Reason For Evaluation:

During the 1R21 Refueling Outage, standing water was found in the trench at elevation 10' 3" in Bay 5 of the Drywell. The purpose of this technical evaluation is to develop a conservative approach to address the worst case concerns associated with the as-found water in the drywell concrete. This evaluation will assess the condition through comparisons of the original UT data taken in 1986, and the UT data taken during the 1R21 outage. Note that the sand and water corrosive environment was removed from the sandbed region in 1992. This evaluation will evaluate these UT results as they relate to potential corrosion concerns based on the current plant configuration with water existing in the drywell concrete area. This evaluation will address immediate concerns in the as-found wetted area of the drywell shell to demonstrate adequate design margins exist (in a worst-case scenario) to support startup of the plant and operation of the plant through the next cycle of operation. The complete assessment of all UT data taken in 1R21 and establishing the associated margins to support operating through the period of extended operation of the plant will be addressed separ

Normal Probability Plot

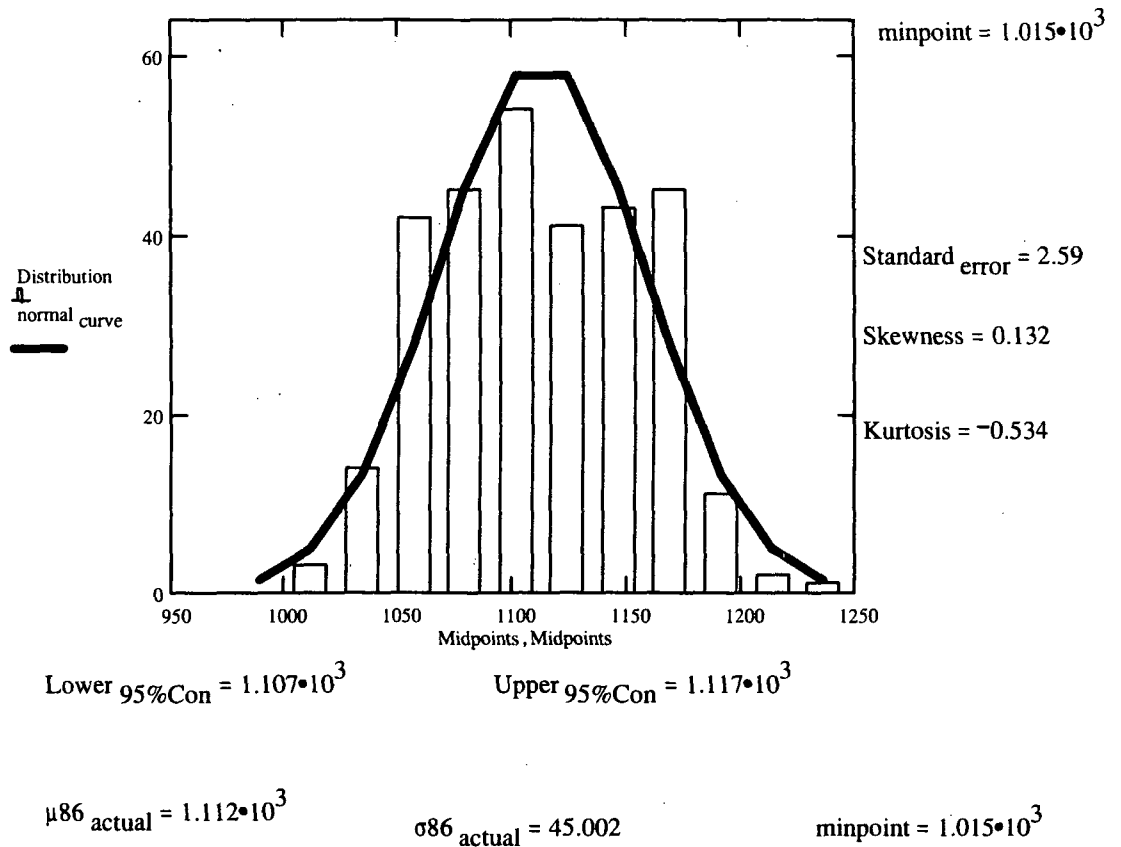
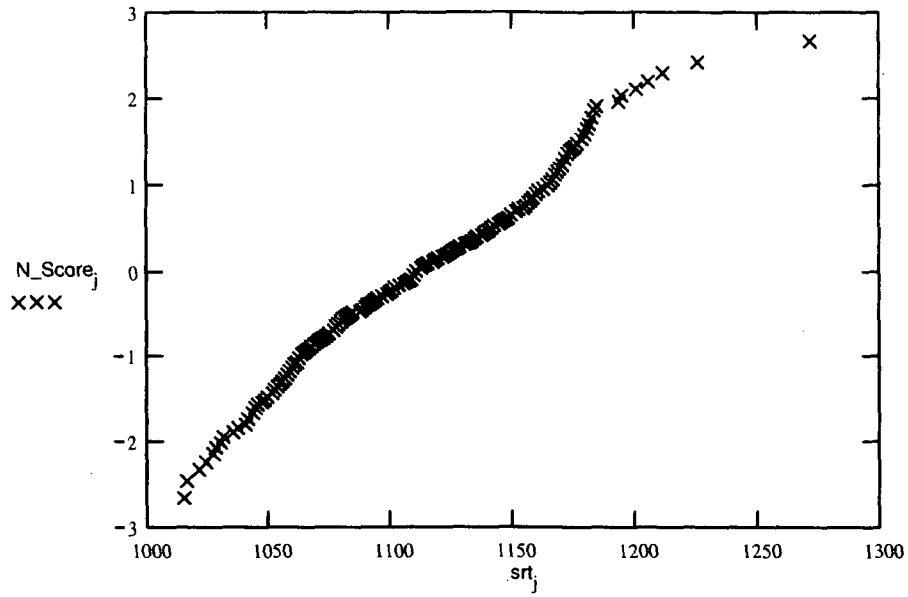
COMMENTS		RESOLUTION	ACCEPTANCE OF RESOLUTION
1	Please define the quantitative acceptance criteria for determining that the data distribution is normally distributed using the kurtosis test (<1.0).	I've defined acceptance criteria a for normal distribution as a Kurtosis value less than +/-1 or a normal distribution plot which approaches a straight line. I've revised attachment 2 pages 16 and 17 and attachment 3 pages 15 and 16 accordingly.	Resolution Accepted
2	Please include in the discussion of the results that the apparent corrosion rate is computed at a 95% confidence interval.	I've revised the summary pages for the trench data comparison, to state that the calculated 1986 and 2006 average thickness values have a 95% confidence.	Resolution Accepted
3			
4			
5			
6			
7			
8			
9			
10			
END			
S. Leshnoff SUBMITTED BY		Peter Tamburro RESOLVED BY	
10/27/06 DATE		10/27/06 DATE

A Kurtosis value which is less than +/- 1.0 and approaches 0 is indicative of a normal distribution

The Normal Probability Plot and the Kurtosis this data is normally distributed.
